### Office Action Summary

10/589,176

## **DETAILED ACTION**

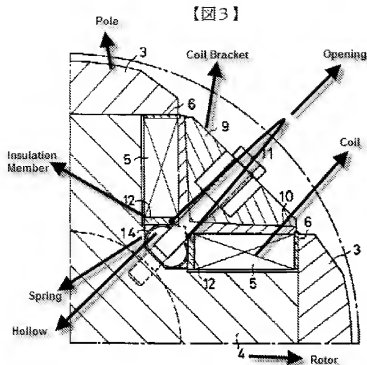
**As to claim 11 and 15**, Horikiri et al. teaches rotor body (4) having a central axis arranged coaxial with a rotational axis (2) of the machine; a pole shoe (3) arranged on the rotor body (4); a field coil (5) extending along the axis of the a rotor body (4) having a portion of the a field coil (5) arranged between a portion of the a rotor body (4) and a portion of the pole shoe (3); and a spring element (14) that exerts a spring force against the field coil (5) forcing the field coil (5) against the pole shoe (3), the spring element (14) having a hollow cross section with an interior portion arranged between the a field coil (5) and the a rotor body(4), wherein an axis of the spring (14) cross section is parallel to the rotor axis (2), and the interior portion of the hollow spring element (14) forms an axial cooling channel of the machine as shown in figure 3. (See Figure 3 below)

**As to claim 12,** Horikiri et al. teaches wherein the entire a field coil (5) is arranged between a portion of the a rotor body (4) and a portion of the pole shoe (3) as shown in figure 3. (See Figure 3 above)

**As to claim 13,** Horikiri et al. teaches wherein the spring is a bent leaf spring (14) as shown in figure 3. (See Figure 3 Above)

**As to claim 14 and 16,** Horikiri et al. teaches wherein the spring (14) has an essentially U-shaped cross section having two limbs like extensions and the field coil (5) is forced against the associated pole shoe (3) by one of the two limbs of the essentially U-shaped section as shown in figure 2. (See Figure 3 in above)

**As to claim 17,** Horikiri et al. teaches wherein the spring (30) has two essentially U-shaped sections which partially overlap to form essentially an O-shape having an opening at one point as shown in figure 3. (See figure 3 in previous Page 3)

**As to claim 18**, Horikiri et al. teaches wherein two field coils(5) are forced against the associated pole shoe (3) by the spring (14) and the opening in the O-shaped spring is arranged such that it points towards a coil support (9) arranged between the two field coils (5) as shown in figure 3. (See figure 3 in previous Page 3)

**As to claim 19**, Horikiri et al. teaches wherein the spring (14) is fixed to the a rotor body (4) by a fixing device on a side of the O-shaped spring opposite the opening in the spring (14) as shown in figure 3. (See Figure 3 in previous Page 3).

**As to claim 25**, Horikiri et al. teaches first spring leg configured to contact a first field coil of the rotor (4) or an insulting block (12) of the first field coil; a second spring leg configured to contact a second field coil of the rotor (4) arranged approximately 90° from the first field coil or an insulting block (12) of the second field coil; and a spring (14) remainder portion spanning between the first and second spring legs configured to contact the rotor (4) and with a provision for accepting a securing device to secure the hollow spring to the rotor (4), wherein the first and second spring legs are in a proximity with one another such that in a stressed state the cross sectional profile of the hollow spring is configured essentially as an O- shape forming an interior portion of the hollow spring where a cooling medium of the salient- pole machine flows as shown in figure 3. (See Figure 3 in previous Page 3)
